CITY PLAN COMMISSION**THURSDAY, AUGUST 8, 2024****FILE NUMBER:** S234-150**SENIOR PLANNER:** Hema Sharma**LOCATION:** Highbury Hill Drive at Ravenhill Road, southwest corner**DATE FILED:** July 10, 2024**ZONING:** N/A**CITY COUNCIL DISTRICT:** N/A**SIZE OF REQUEST:** 17.379 -acres**APPLICANT/OWNER:** Devonshire Residential Association

REQUEST: An application to replat a 17.379-acre tract of land containing portion of Lot 1 in City Block EE to create one 4.38-acre lot and one 13.00-acre lot on property located in the Dallas Extra Territorial Jurisdiction (ETJ) on property located on Highbury Hill Drive at Ravenhill Road, southwest corner.

PRELIMINARY PLAT
DEVONSHIRE
COMMUNITY CENTER
 LOT 1393 & 1394
 OUT OF THE
 JUAN LOPEZ SURVEY, ASSISTANT NO. 188
 CITY OF DALLAS
 COUNTY OF DALLAS, TEXAS
 FILE NO. 234-150

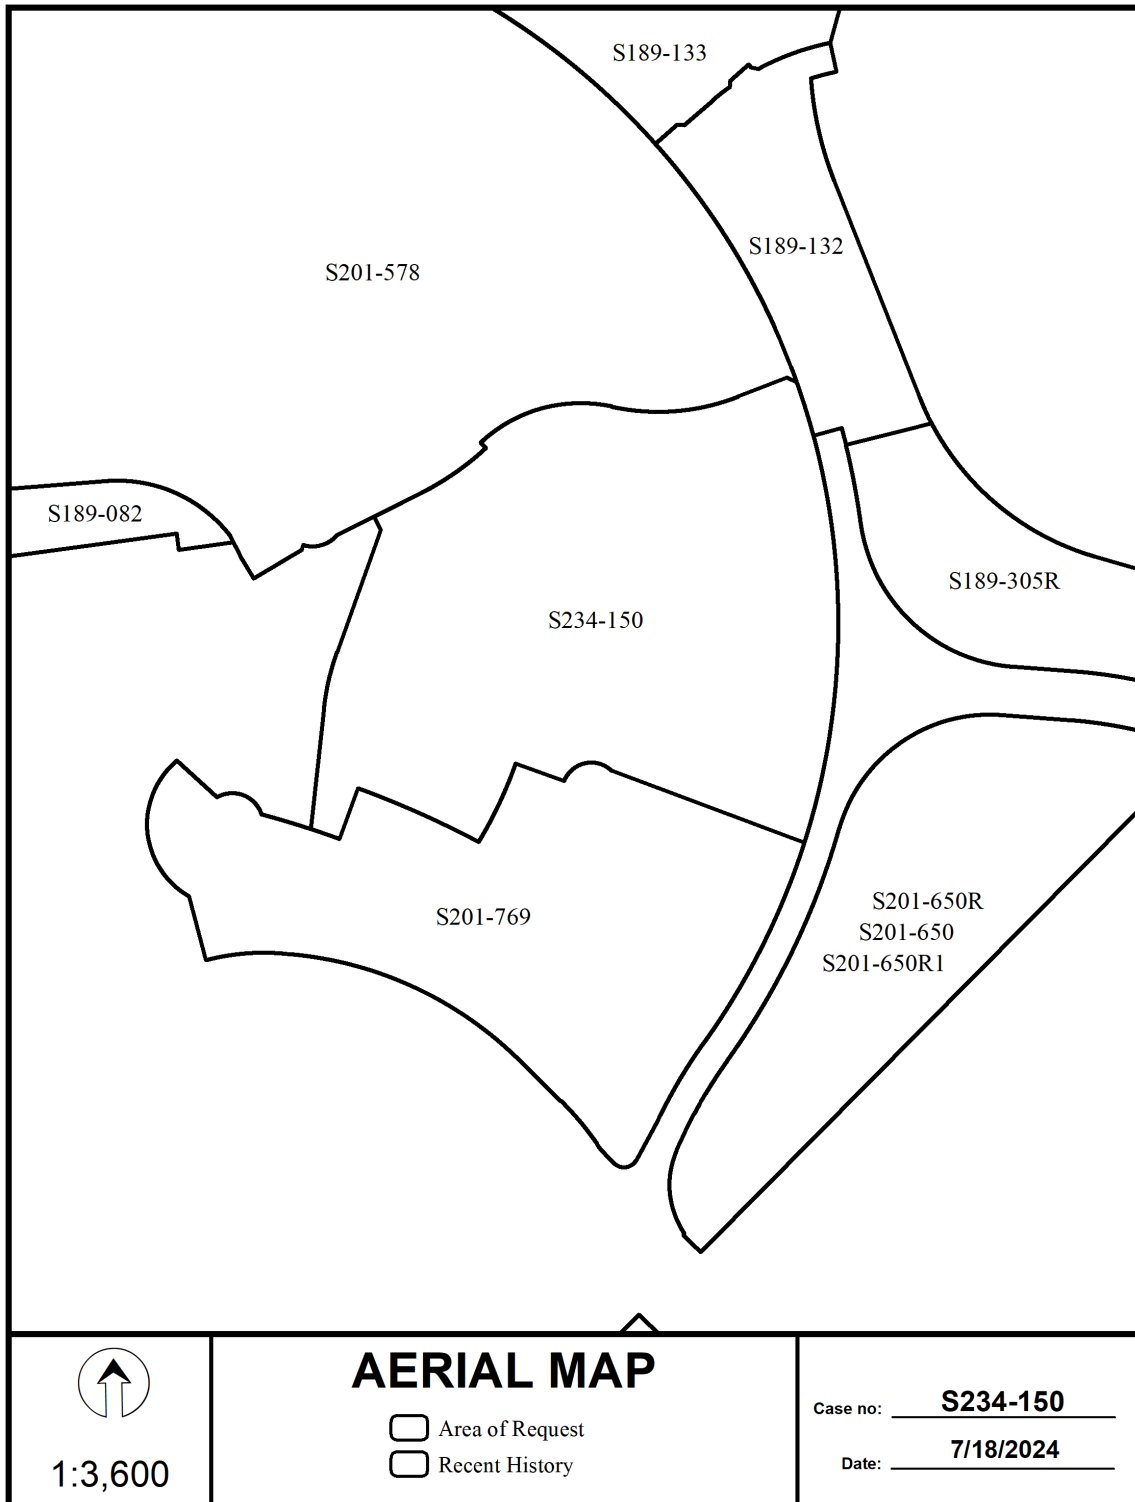
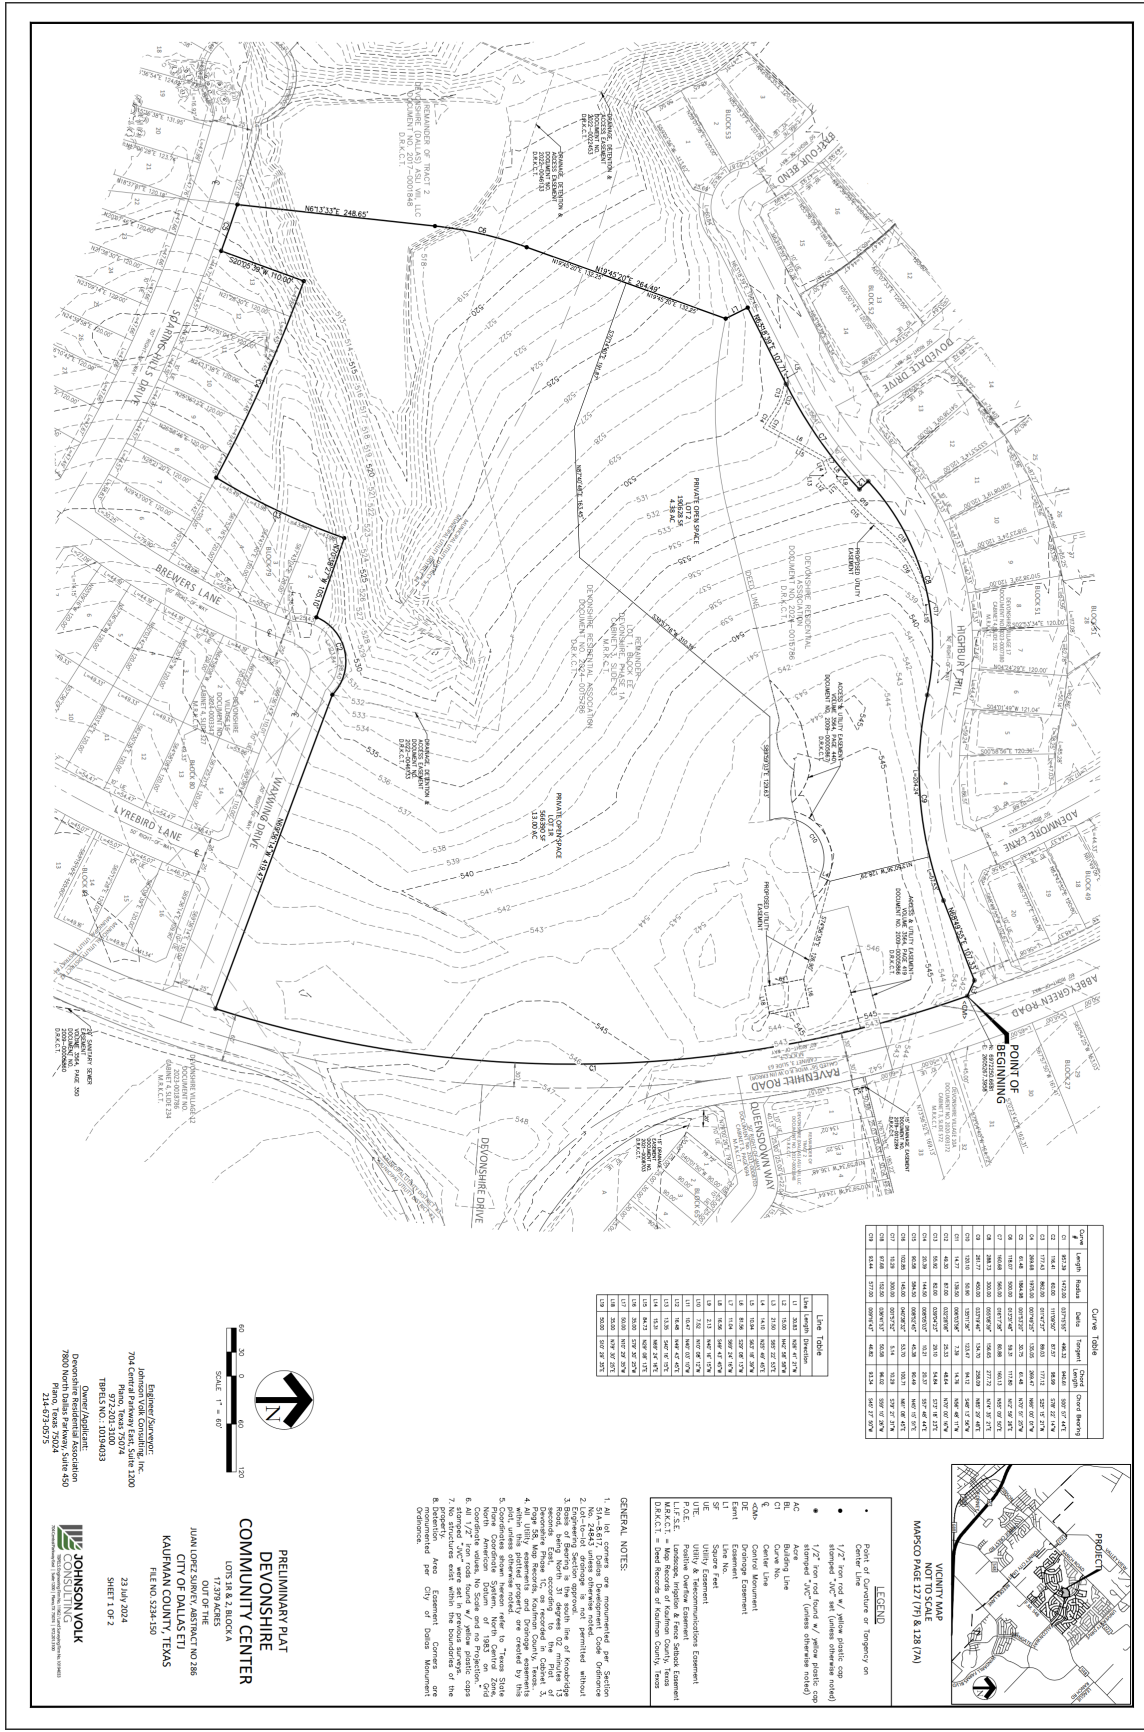
STAFF RECOMMENDATION: The request complies with the requirements of the Dallas Extra Territorial Jurisdiction (ETJ); therefore, staff recommends approval of the request subject to compliance with the following conditions:

5. Any new or existing structure may not extend across new property lines. *Section 51A-8.503(e)*
6. On the final plat, all easement abandonments, and ROW abandonments must be by separate instrument with the recording information shown on the face of the plat. A release from the Real Estate Division is required prior to the plat being submitted to the Chairman for signature.

7. On the final plat, include two boundary corners tagged with these coordinates: "Texas State Plane Coordinate System, North Central Zone, North American Datum of 1983 on Grid Coordinate values, No Scale and no Projection."

8. On the final plat, monument all set corners per the Monumentation Ordinance. Prior to submittal of the final plat for the Chairman's signature. The monuments must be verified by the Chief City Surveyors Office in the Public Works Department. *Section 51A-8.617*

10. Prior to the final plat, submit a tree survey to the Arborist. A release from the arborist is required prior to an early release request or the recordation of the plat, whichever occurs first.
11. The number of lots permitted by this plat is 2.

16. On the final plat, dedicate a minimum 5-foot by 5-foot corner clip (via fee simple or street easement) at the intersection of Waxing Drive & Ravenhill Road. Section 51A 8.602(d)(1)
17. On the final plat, dedicate a minimum 5-foot by 5-foot corner clip (via fee simple or street easement) at the intersection of Ravenhill Road & Highbury Hill. Section 51A 8.602(d)(1)
18. A larger corner clip may be requested during engineering plan and traffic review to accommodate an adequate turning radius, or to maintain public/traffic appurtenances, within the area of the corner clip. *Section 51A 8.602(d)(1), 51A 8.608(a)*

19. Prior to final plat, submit a completed final plat checklist and all supporting documents.
20. On the final plat, show how all adjoining right-of-way was created. Section 51A-8.403(a)(1)(A)(xxii).
21. On the final plat, show recording information on all existing easements within 150 feet of the property.
22. On the final plat, show all additions or tracts of land within 150 feet of the property with recording information.

23. On the final plat, show or list the prior plat on the map, in the legal description, and/or title block.

24. Engineer must furnish plans for water and sanitary sewer. Developer must furnish a contract for water and sanitary sewer. Sections 49-60(g)(1) and (2) and 49-62(b), (c), and (f).
25. Additional design information is required for assessment. Site plan must be submitted showing proposed development, building finished floor elevation, development, existing mains – including downstream manhole, and proposed water and wastewater service locations. Submit water/wastewater engineering plans to 320 E. Jefferson Blvd., Room 200, Attention: Water and Wastewater Engineering.
26. Water and Wastewater main improvements is required by Private Development Contract. Submit water/wastewater engineering plans to 320 E. Jefferson Blvd., Room 200, Attention: Water and Wastewater Engineering.
27. Must comply with DWU regulations construction of utilities in Dallas E.T.J.
